Data Response Set 2 (Responses to Data Requests 1 to 11)

Submitted to
California Energy Commission

Elmore North Geothermal Project
(23-AFC-02)
October 27, 2023

Figure DRR 10a-1
 Salton Trough Tectonic Map,
 Black Rock Geothermal Project
 Imperial County, California

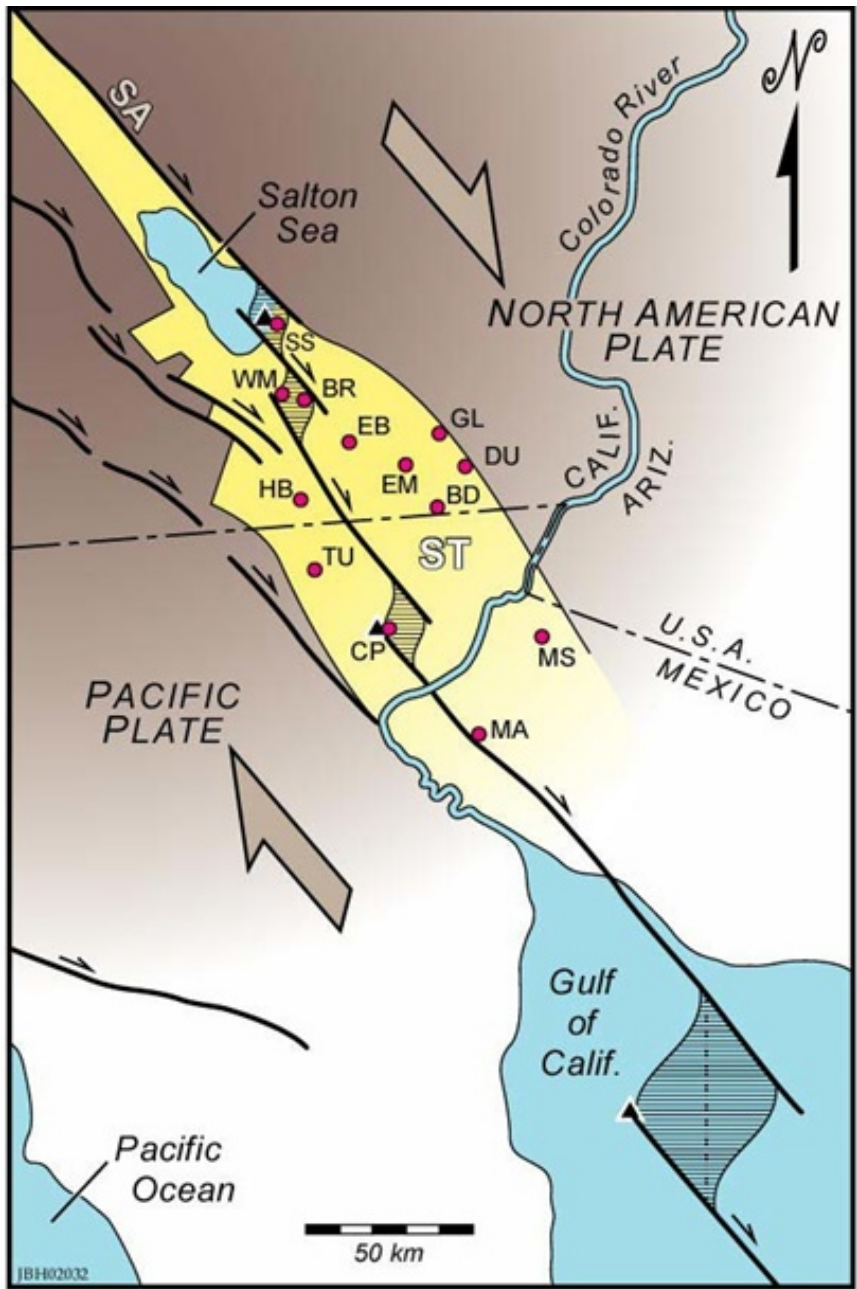
10. *To allow environmental review of the potential impacts of the whole of the project, please provide preliminary information used for planning injection well installation, as follows):*
 - a. *Known properties of the injection reservoir*
 - b. *Well diagram of proposed injection wells*
 - c. *Contour map of the top of the intended injection zone*
 - d. *Cross-section showing injection wells and the injection and overlying formations*

a. Known properties of the injection reservoir

The Salton Sea geothermal reservoir occurs in fractured sedimentary rocks within the Salton Trough, a structural depression on the boundary between two tectonic plates. The northwest motion of the Pacific Plate on the west, relative to the North American Plate on the east, has created regional right-lateral faults striking NW-SE and local conjugate left-lateral faults striking NE-SW shown as Figure 1 in the report titled "*Geology and a Working Conceptual Model of the Obsidian Butte (Unit 6) Sector of the Salton Sea Geothermal Field* (Hulen et al., 2003²). A copy of this figure is provided as Figure DRR 10a-1. The Salton Trough began its existence in Oligocene to Miocene time as a coaxial but smaller and shallower proto-rift, developed as a Basin and Range-style back-arc basin in response to subduction of the Farallon plate beneath the North American plate. Oligocene to Miocene basalts along the margins of the modern Trough attest to the lithospheric thinning, heating, and mafic-alkaline magmatism that accompanied the older rifting episode. The nature of the basement in the Trough remains conjectural. Gravity and seismic data suggest that low-density (2.3-2.55 g/cm³) sediments rest upon an intermediate-density (2.65 g/cm³) basement extending to about 39,000 feet depth. The intermediate basement, in turn, overlies a higher density (3.1 g/cm³) layer extending to the base of the crust at about 77,000 feet. This deep layer is inferred to be gabbro, added to the crust to compensate isostatically for the low-density sediments supplied from above (Hulen et al., 2002³).

Heat sources for the high-temperature geothermal systems of the Salton Trough have traditionally been envisioned as gabbroic. The Salton Trough is filled to a depth of approximately four (4) miles with Colorado River sediments, interbedded with salt deposits from periods of lake evaporation. Within the Salton Sea field, past volcanic activity is indicated by five outcrops of rhyolite - Obsidian Butte, Rock Hill, Red Island (North and South), and Mullet Island) - as well as extrusive and shallow intrusive igneous rocks encountered in several wells.

Figure DRR 10a-2
 Salton Sea Shallow Thermal Gradient,
 Black Rock Geothermal Project
 Imperial County, California

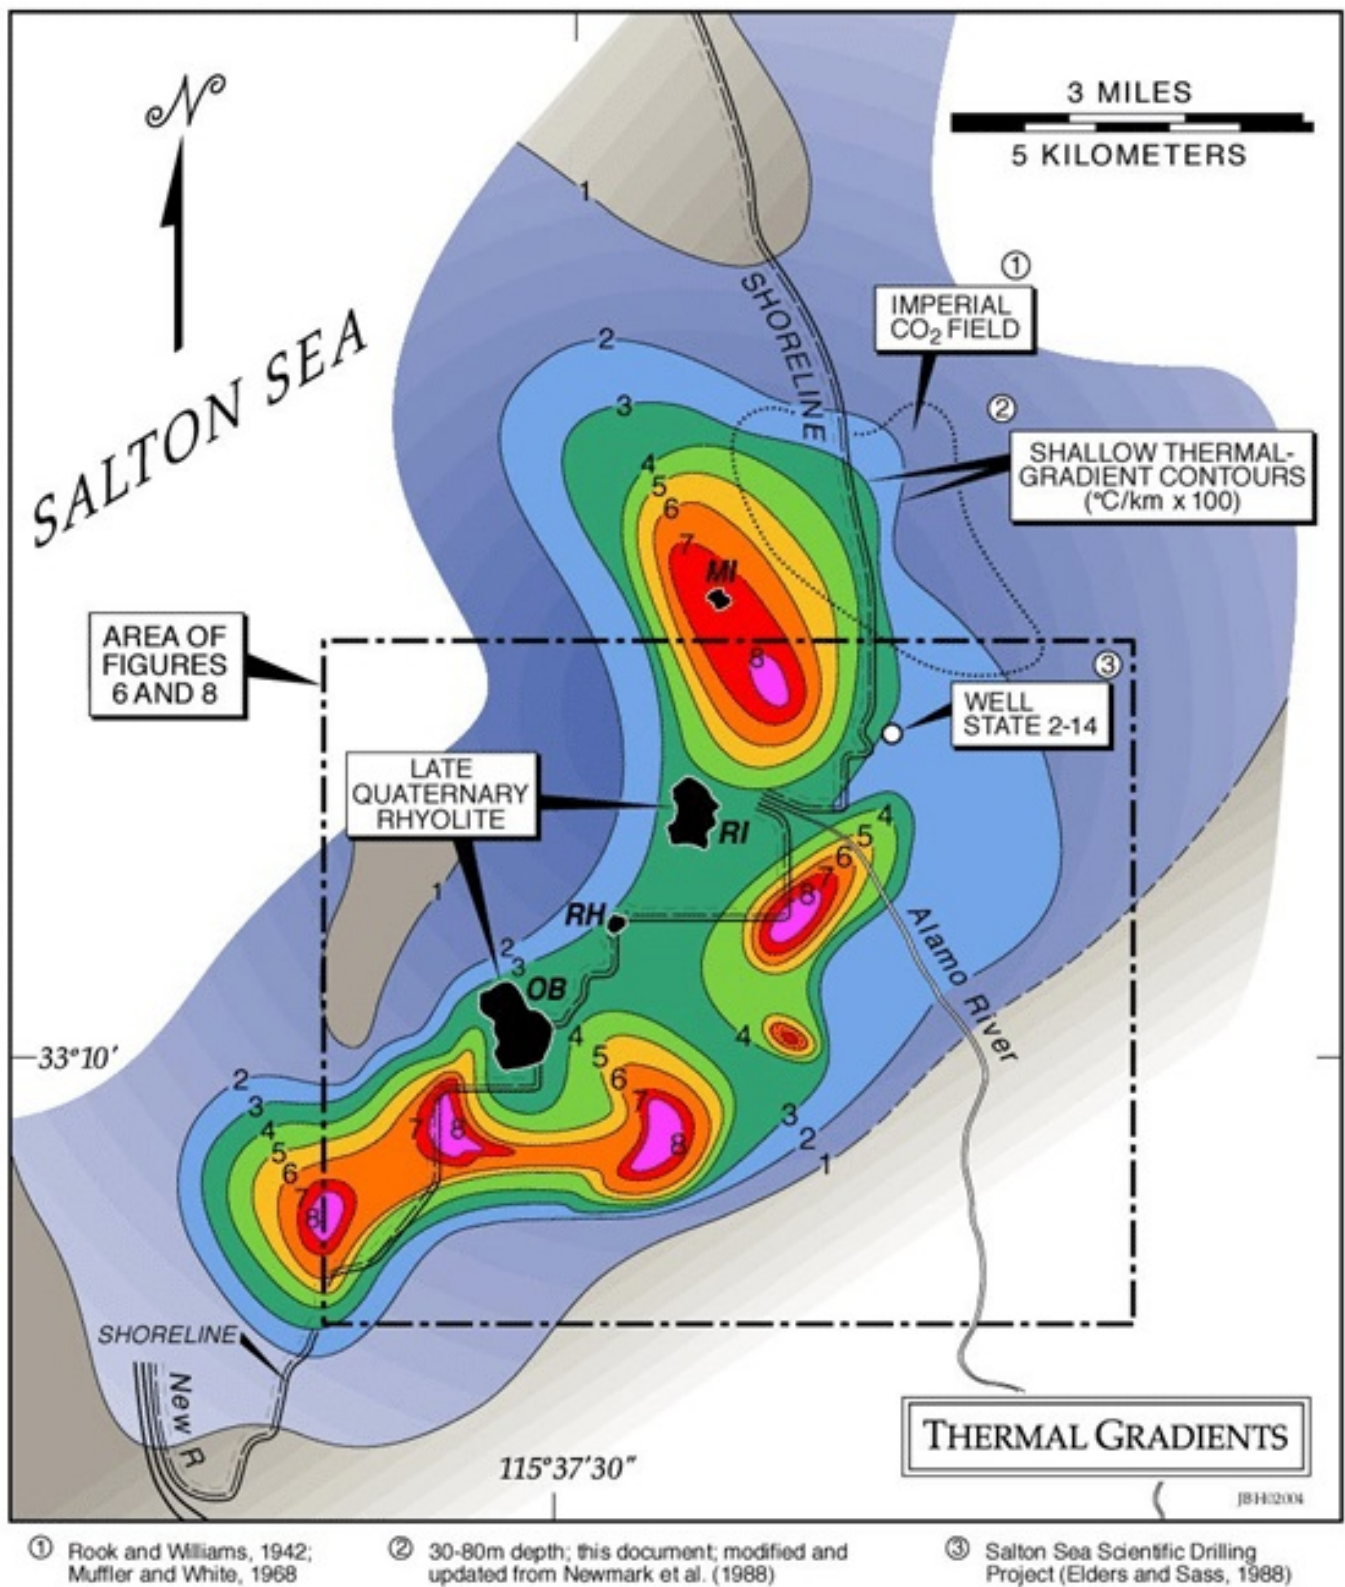
Reservoir Properties (Temperature, Pressure, and fluid chemistry)

Figure 2 in the report entitled "Refined Conceptual Modeling and a New Resource Estimate for the Salton Sea Geothermal Field, Imperial Valley, California; Proceedings" identifies the shallow thermal gradient anomaly compiled with data available through June 2002 (Hulen et al. 2002). A copy of this figure is provided as Figure DRR 10a-2. The reservoir temperature at 1,350 feet below mean sea level (msl) is shown in Figure 2.1 of the resource adequacy report entitled "Numerical Reservoir Simulation of the Salton Sea Geothermal Resource for Power Generation," dated May 2023 (TN No. 250040) which was provided to CEC. The reservoir pressure is shown in Figure 2.2 of the resource adequacy report. Expected fluid composition is shown in Table 2-2 of the Application for Certification for the Elmore North Geothermal Project.
